Administrative Office of the Courts

Amendment #2 Request for Proposals Project # K20-0074-61C Security Upgrade for Hyattsville DC Commissioner

Commissioners' Entrance Issued by: Christos Bazekis Procurement Officer March 3, 2020

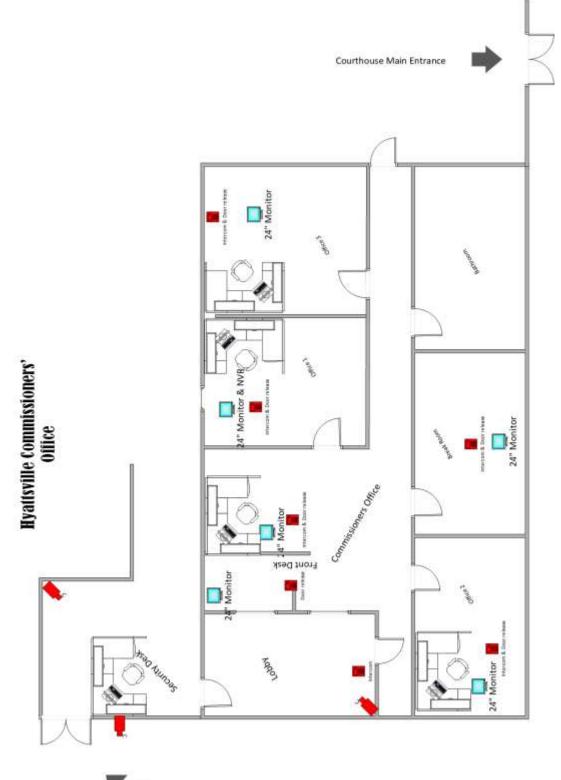
c. In the Commissioner's Lobby, (1) existing camera will be removed and replaced. (1) intercom system with door release will be installed next to the commissioners' entrance door 5 feet from the floor.

4. Add the following Drawing:
